PERMIT SET

COURTYARDS - BUILDING E

SIGNER : DAS	DRAWN : DAS	
ARCHITECT : DAS	CHECKED : AAT	
ENGINEER :	APPROVED : CRJ	
REVISION DESCRIPTION		DATE
Rev 1 - Permit Comments		02/15/24

DRAWING TITLE
ENLARGED PLANS

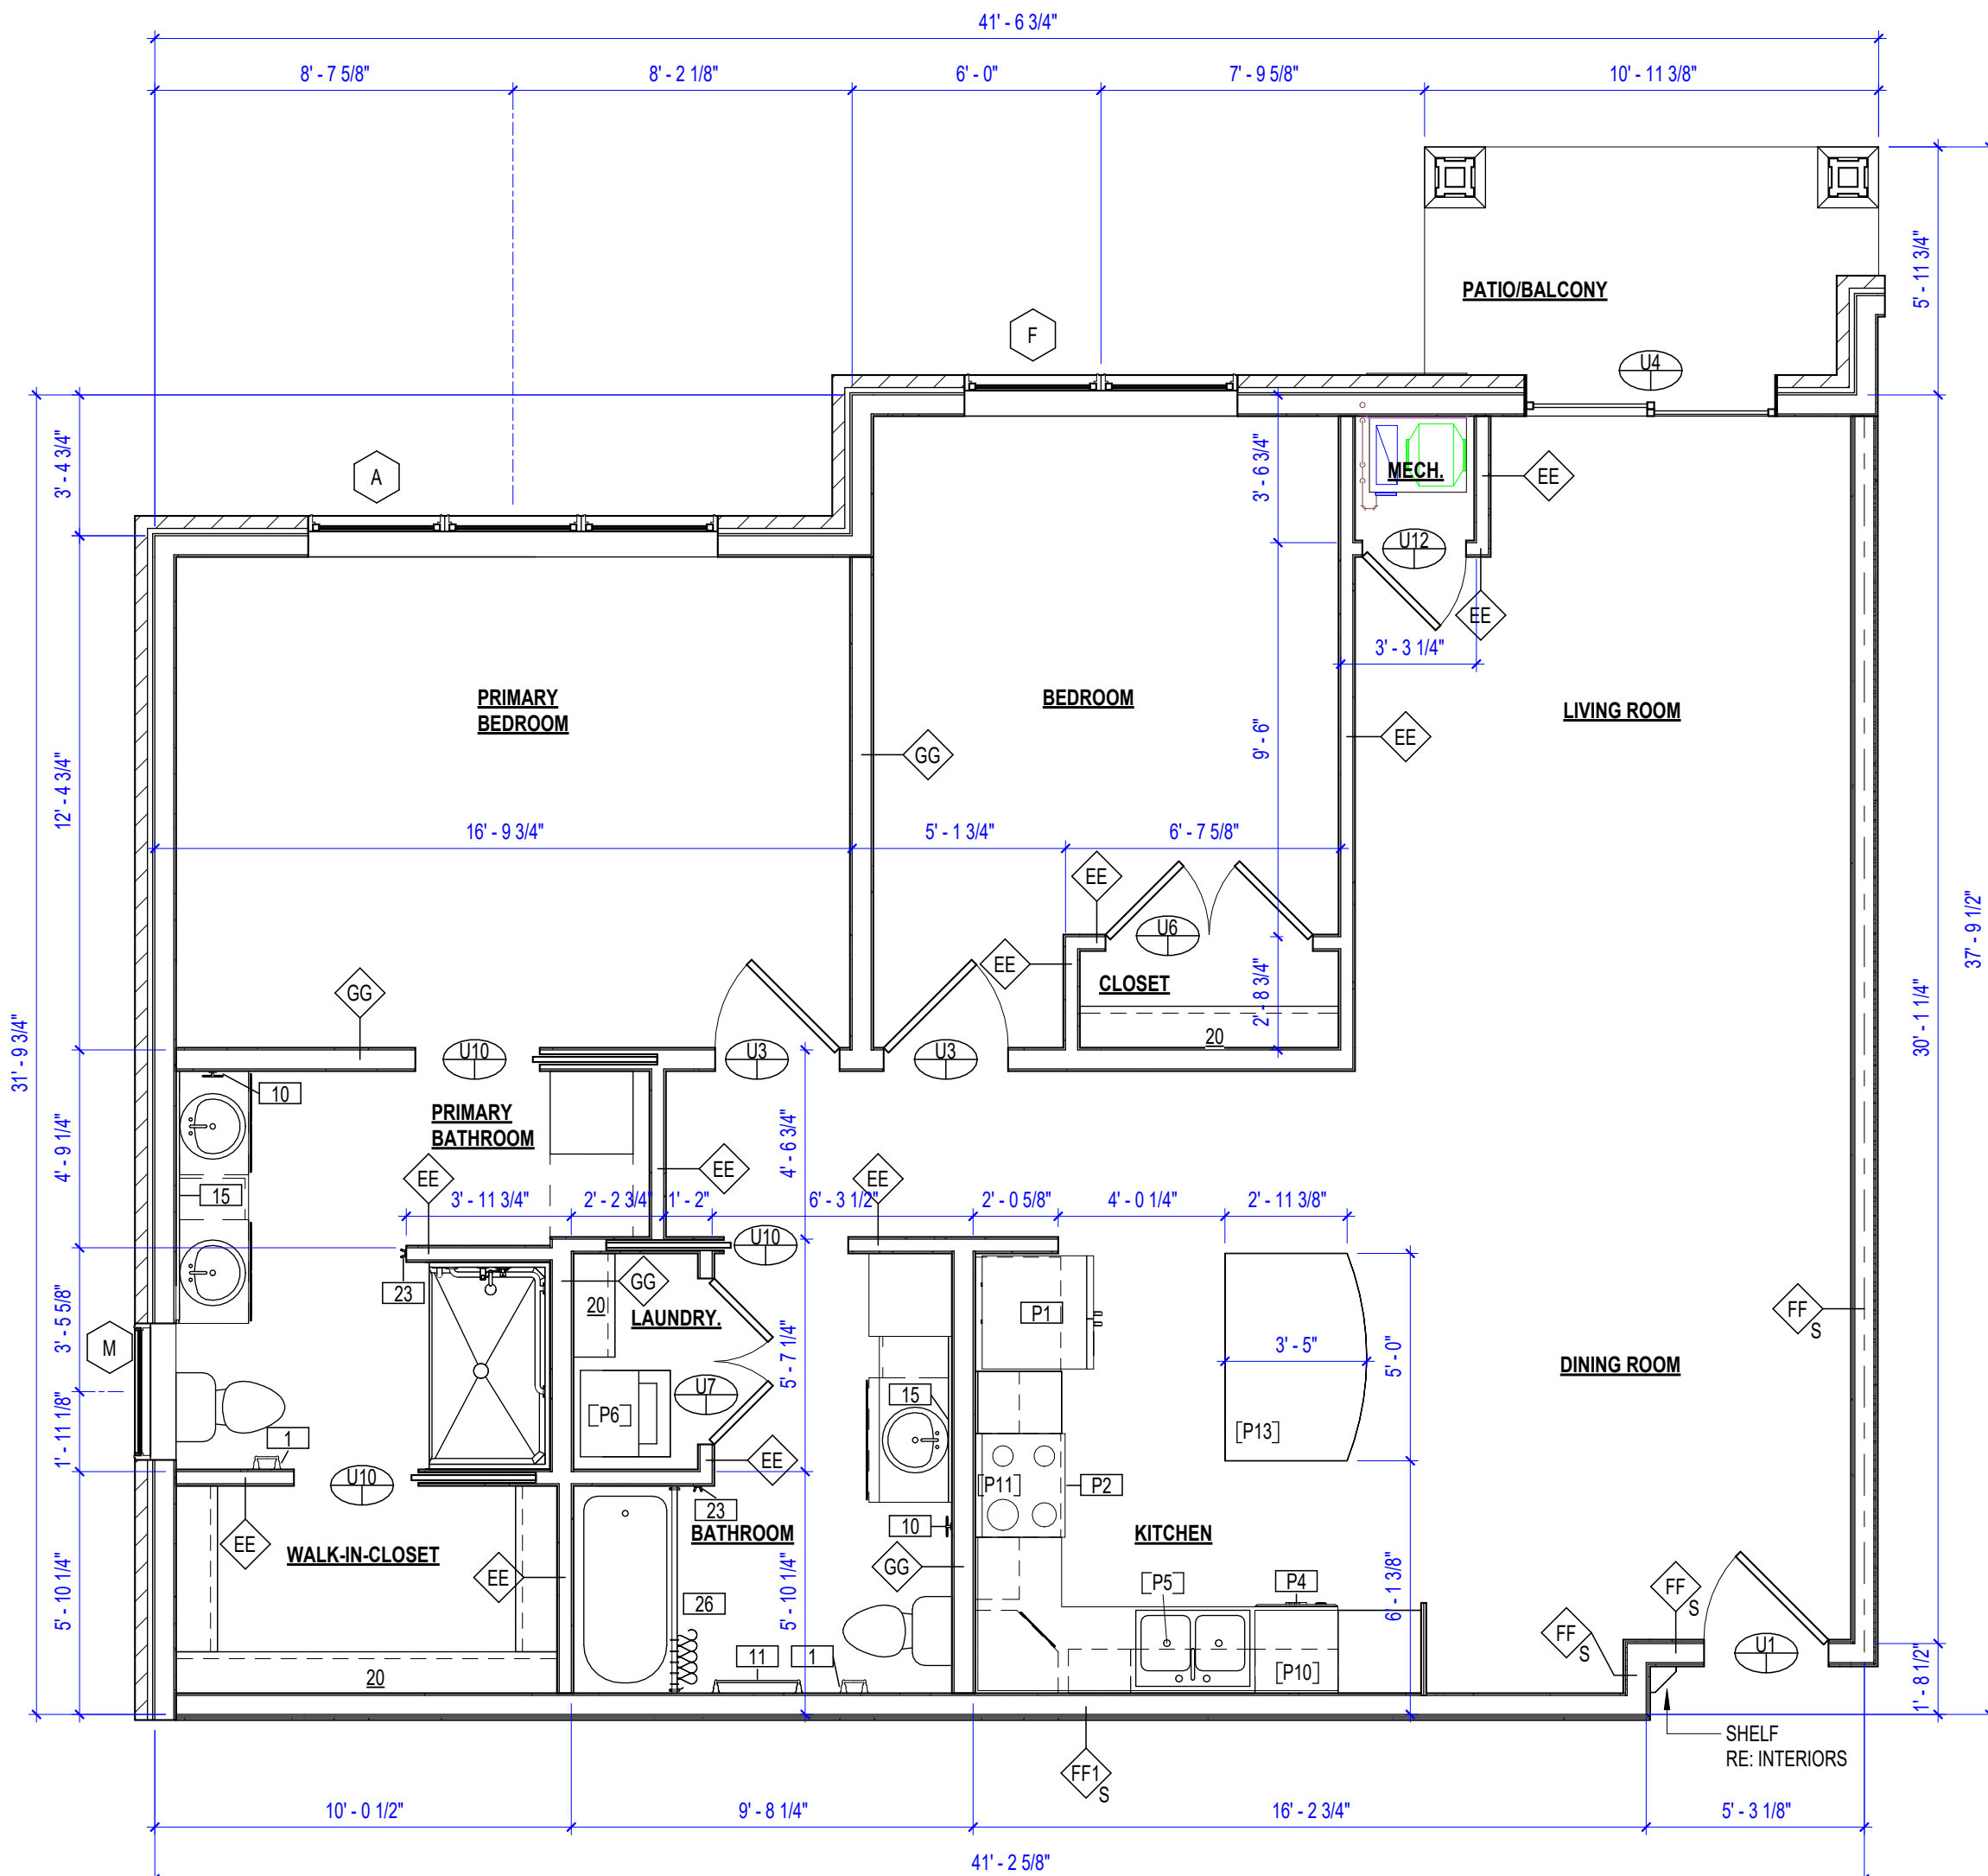
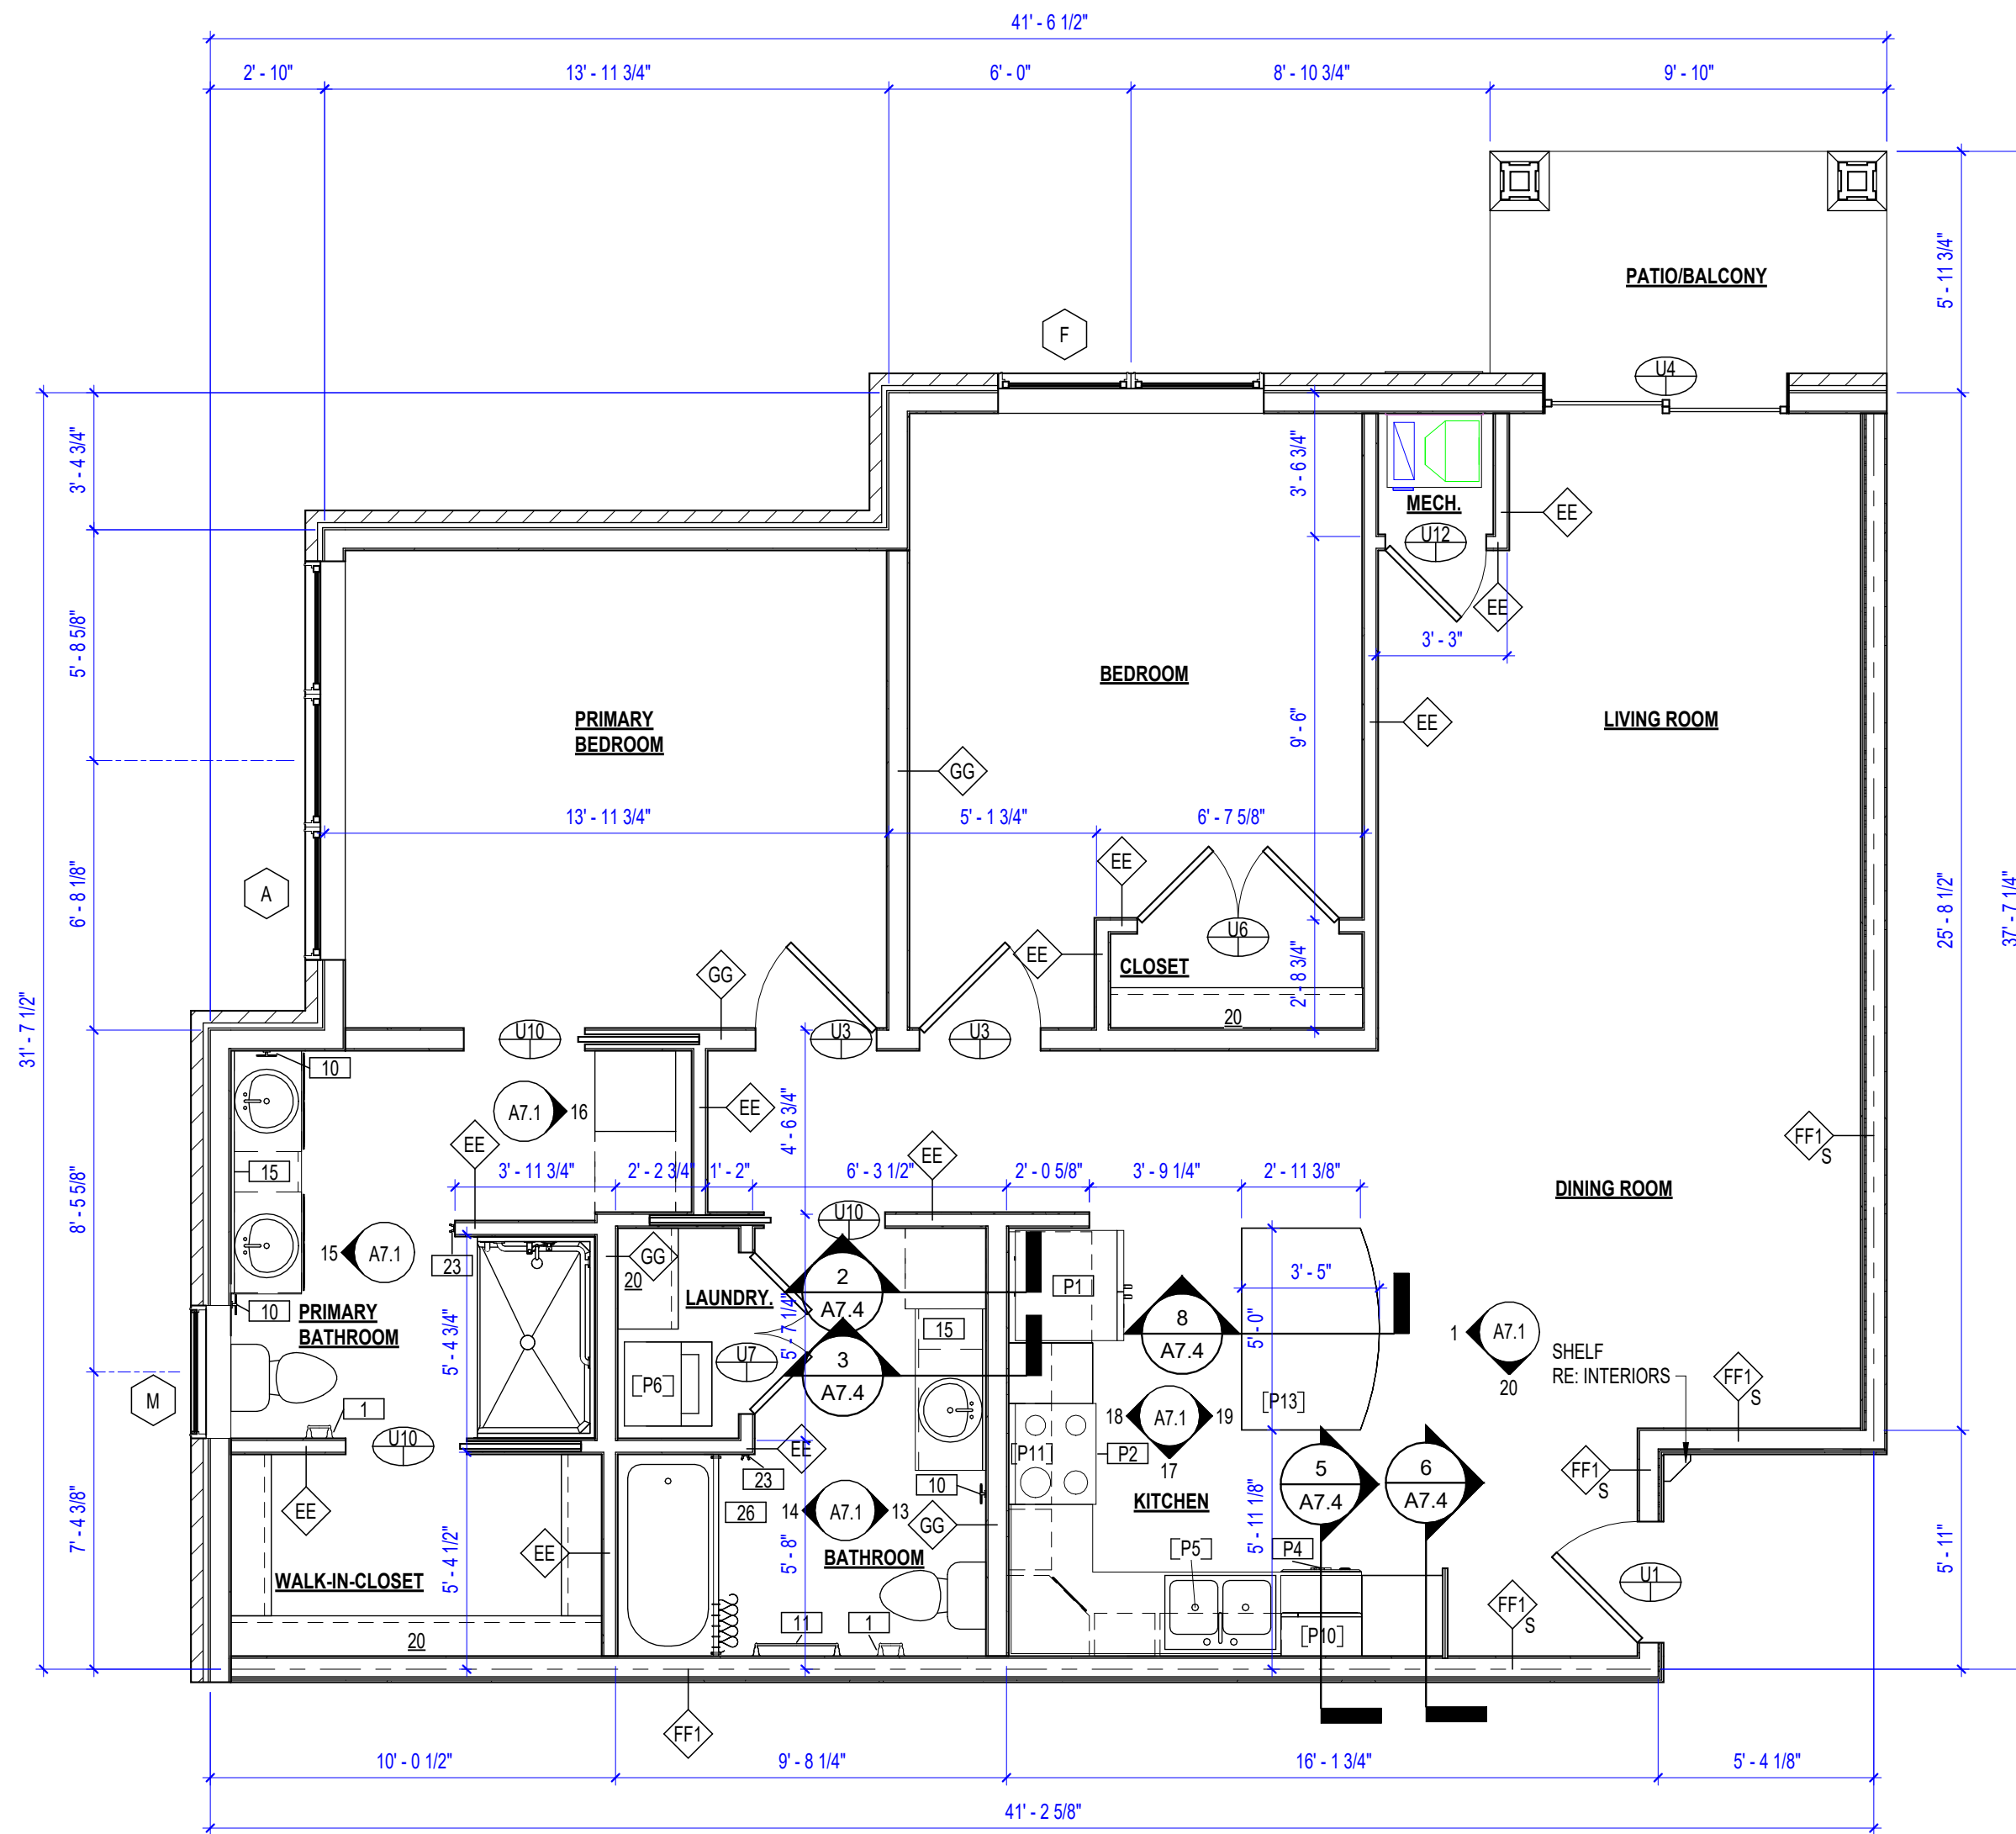
DIMENSIONS ADDED AND ADJUSTED
